Addendum #1

Attn: Estimator	Date: November 14, 2024
From: Lisa Donahue, Project Administrator	Pages: 58 (including cover page)
Re: Bullock Creek School District 2024 Bond Series 1	Project: 2025 Summer Projects HS/MS/Elem/Pine River/Floyd and Maintenance Building
CC:	Proj. #: A24907

Project: No. 24-120 2023 Bond – Series 1 2025 Improvements

Issue Date: November 14, 2024

R
Q
P
N
M
L
K
J
H
G
F
E
D
C
B
A

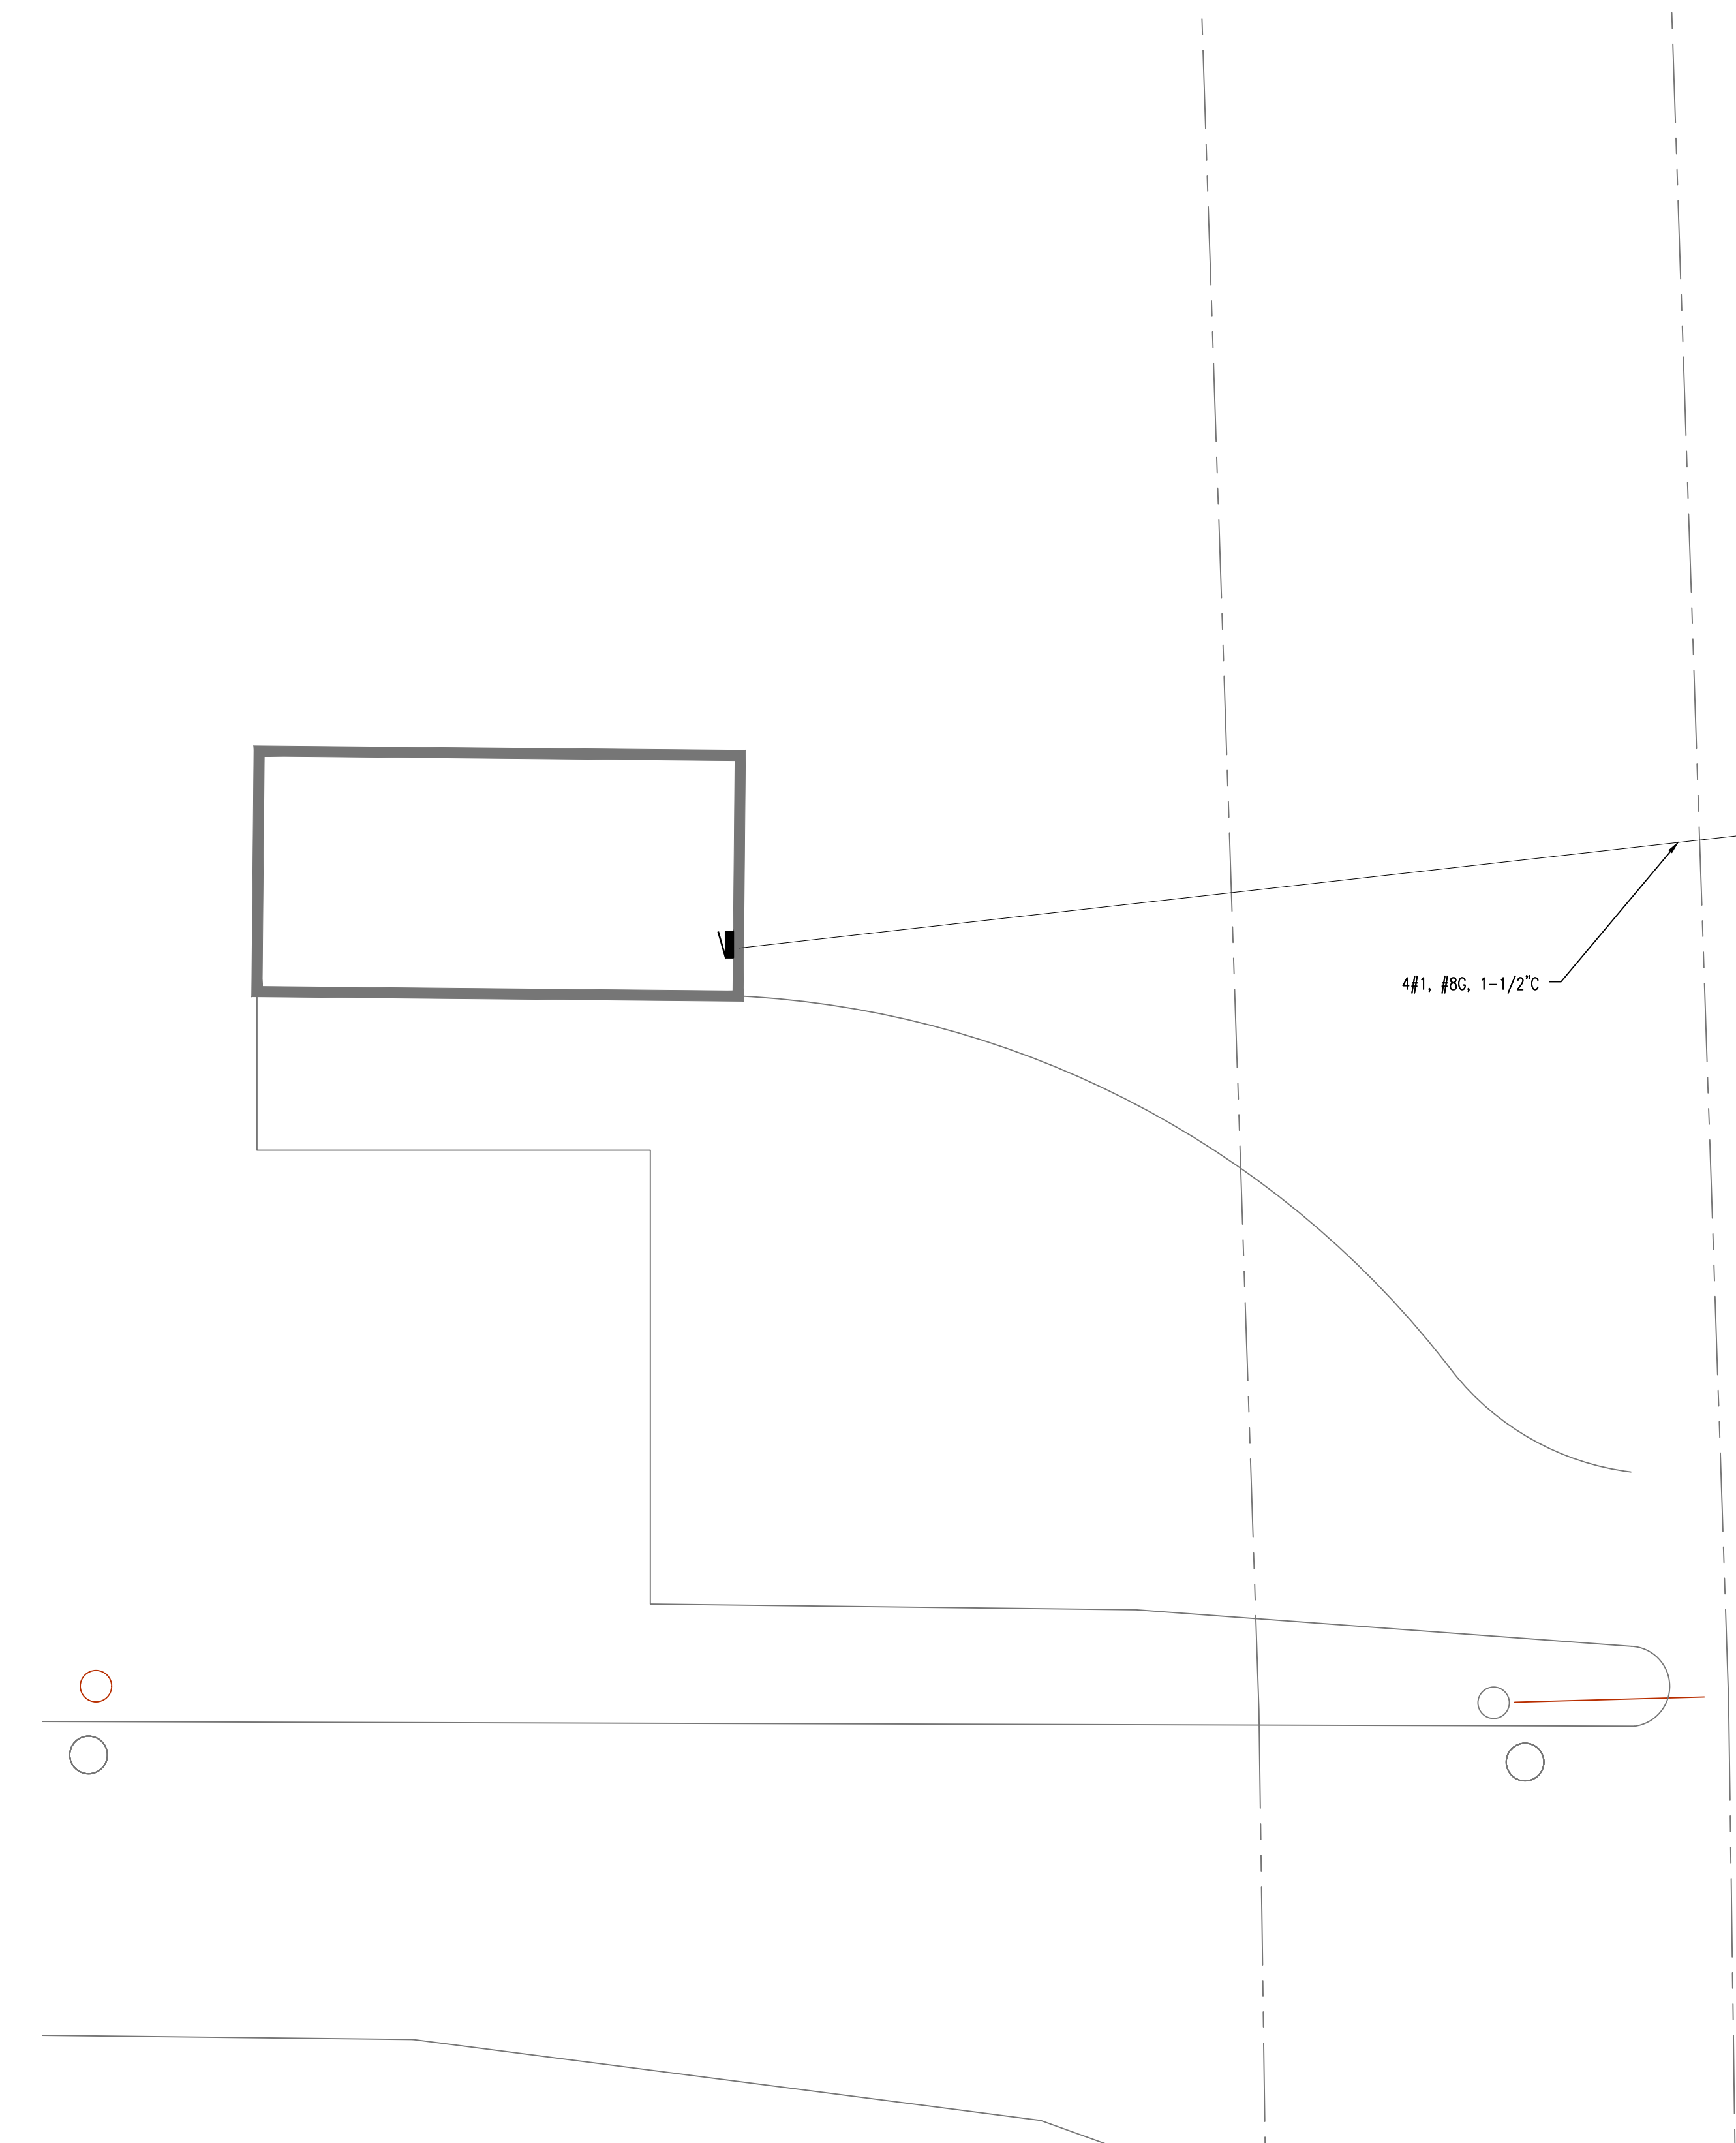
Item #E2: Revise Sheet F-E102 as follows:
a. Picture added of existing panel in existing shed for clarity of work.
